Staff Report to the Planning Commission

PCU2025-0002, PSP2022-0020, and PTP2025-0004

Gas Station Renovation

3420 S. Rochester Rd.

Site Plan

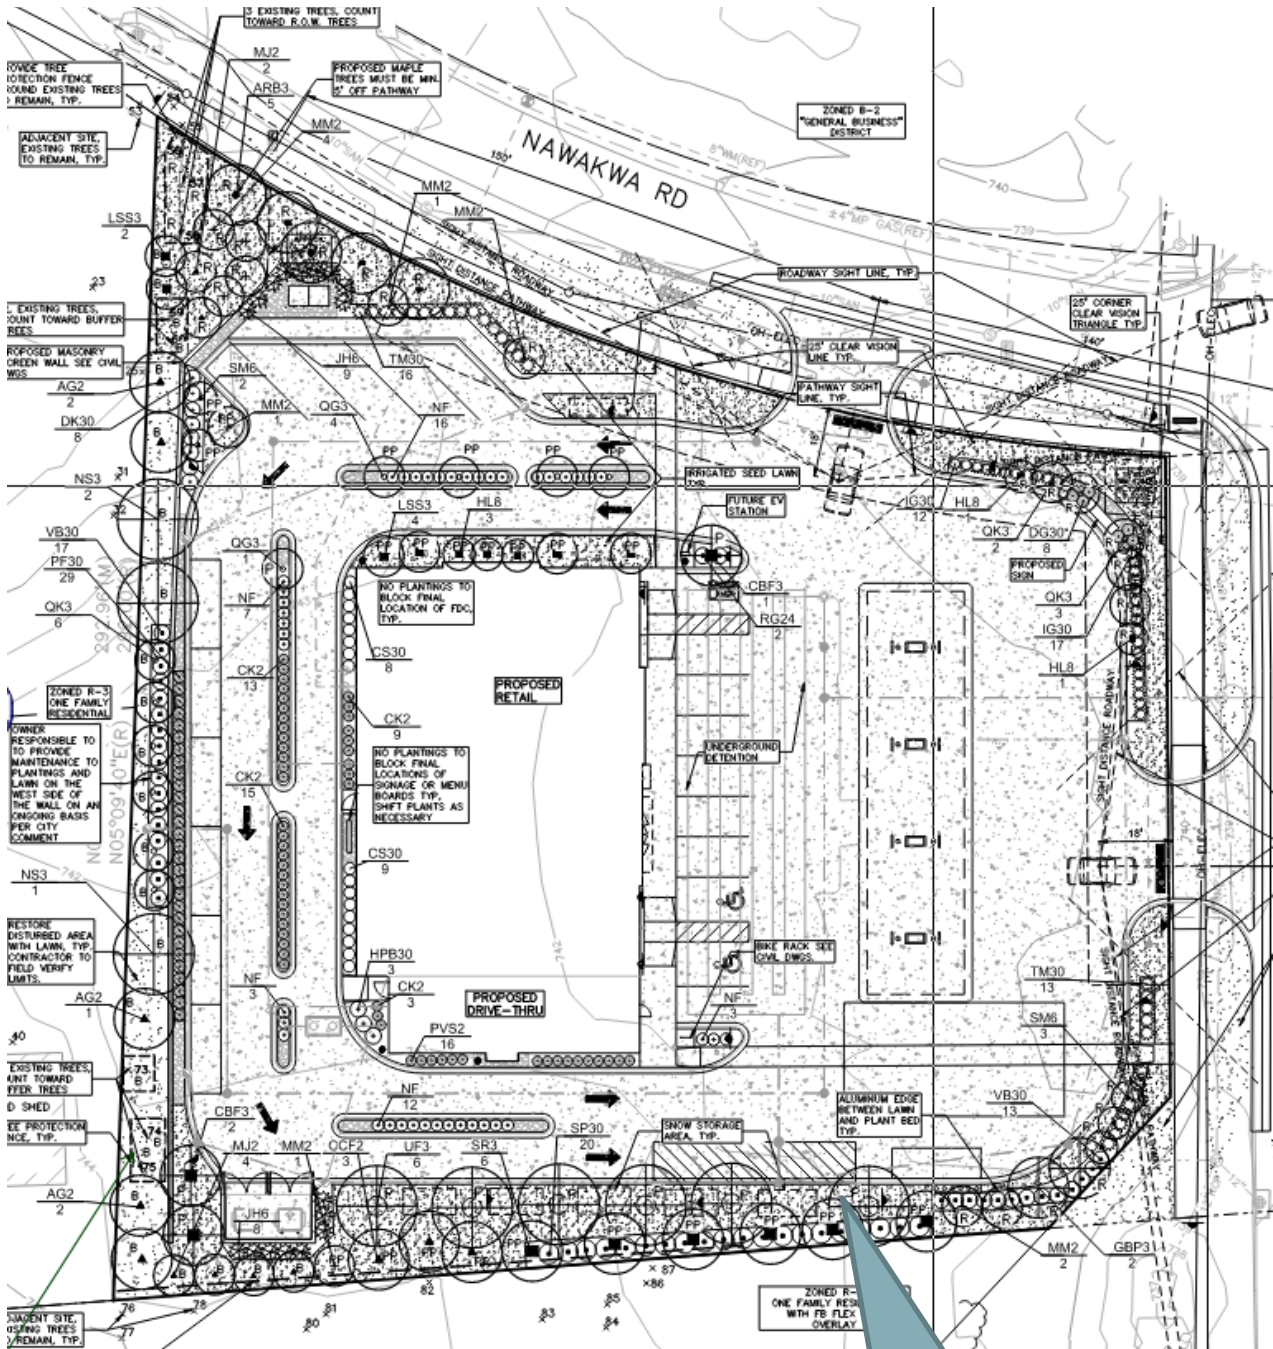
The vehicle circulation plan has also been modified on the proposed plans to reduce the total number of driveways to and from the site from three (3) driveways to two (2). The site currently has a single driveway access on Nawakwa. That driveway will generally stay in its current location, being slightly moved to the west and will be reconstructed to comply with current specifications.

The site currently has two (2) driveways along S. Rochester Road. These driveways are angled and are likely intended to be directional driveways onto S. Rochester Road. The first driveway is located very close to the intersection of Nawakwa and S. Rochester Road. The second driveway is located to the south end of the site along S. Rochester Road. These two (2) driveways will be consolidated into a singular driveway for both ingress and egress, towards the central portion of the site in an effort to maximize the separation from the intersection of Nawakwa and S. Rochester Road and the onramp for M-59 to the south and therefore provide greater safety to drivers and pedestrians.

convenience and food user along the front (east) side of the building, and additional overflow parking along the north property line (angled parking configuration) and west property line (parallel parking spaces). The drive through stacking lanes will circle the building, on the south, west, and north sides of the building. The stacking lanes will be separated from the adjacent maneuvering lanes, servicing the parking spaces by landscape islands consistent with the City's Ordinance requirements. The site plan is compliant with the number of stacking spaces required by the City (10). However, since the site is accessed by S. Rochester Road, MDOT review of the driveway/access is also required. MDOT has an additional drive through use standard it applies to uses along S. Rochester Road, requires a more significant stacking lane and number of stacking spaces beyond what is required by the City. These spaces are shown on the site plan but extend much further around the site than those required by the City. The City, in review of the site plan, only applied City requirements, such as the physical separation between stacking lane and maneuvering lanes to those number of spaces specifically required by the City, not the additional spaces required by the State.

In regard to pedestrian accessibility, the site plans propose two (2) separate pedestrian connections to the pedestrian pathway system along S. Rochester Road and the proposed sidewalk along the south side of Nawakwa. These pathway connections will be ADA compliant, providing full access to and from the site for all users. The site plan also proposes the installation of a new bicycle rack near the southeast corner of the building for bicycle parking consistent with the City's proposed ordinance amendment currently being considered. The bicycle rack will also be consistent with the City's adopted streetscape plan.

Renderings

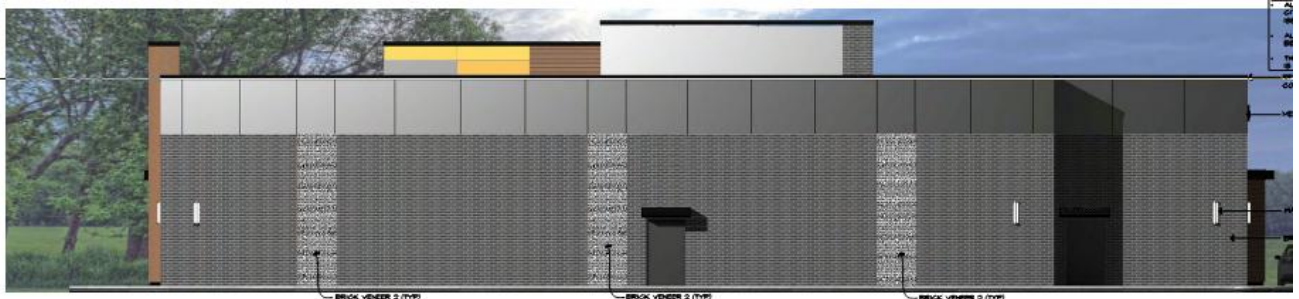
The building architecture provides for a modern design and the building materials include a mix of masonry brick material, metal paneling along with wood composite siding. The building materials vary from some of the more traditional building materials seen in the City and should be closely reviewed by the Planning Commission. The building design is very similar to the recently approved gas station demolition and remodeled approved by the Planning Commission on Crooks Road. City staff has discussed the overall building design and materials with the applicant and this is the proposal the applicant wanted to present. The redevelopment of the site will also include a new gas pump canopy that is supported by masonry brick columns.

Floor Plan

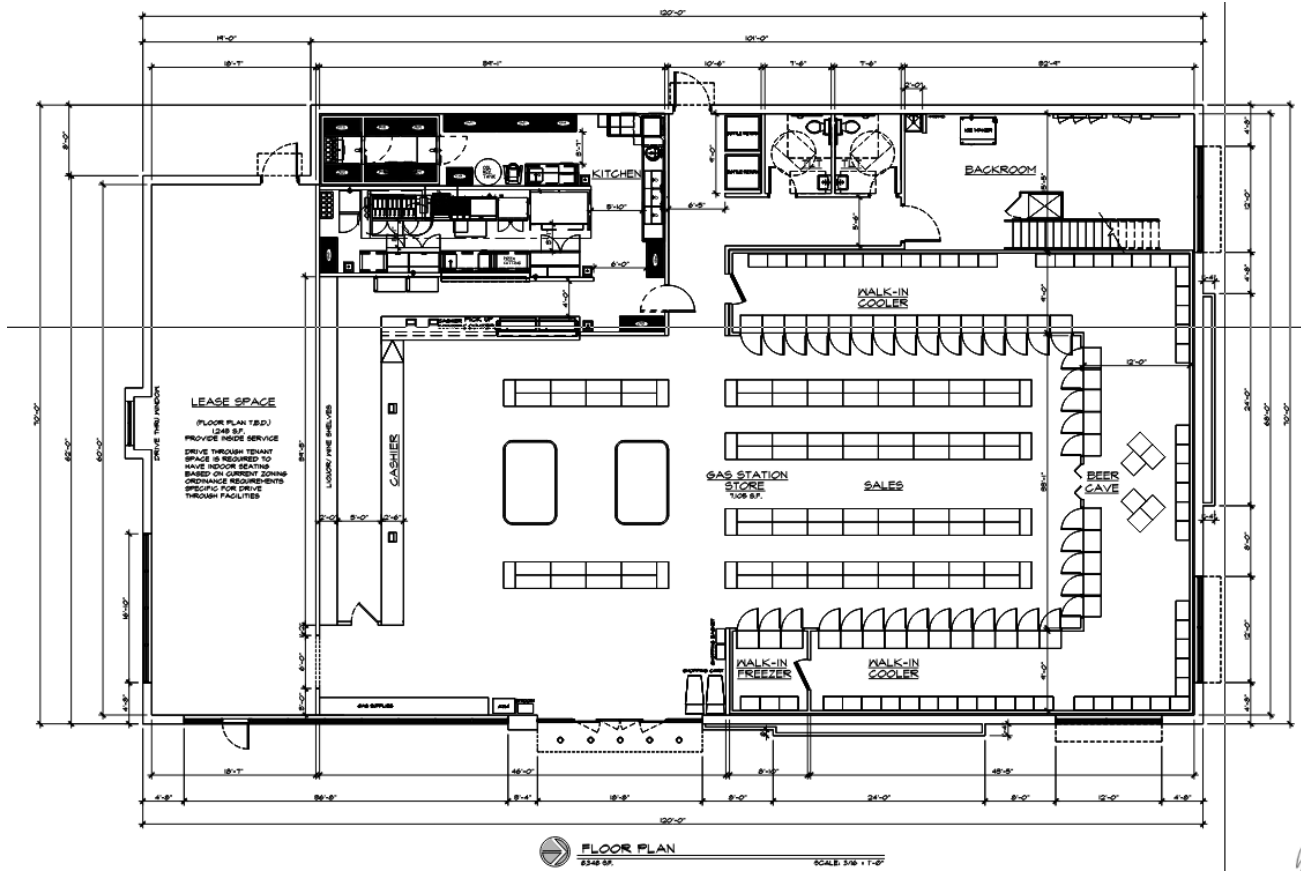
6. *Any use with a drive-through shall also provide customers with a means of accessing services inside the building. Although no specific user and therefore no specific floor plan has been provided for this space, the floor plan does note that the use is required to have indoor seating.*
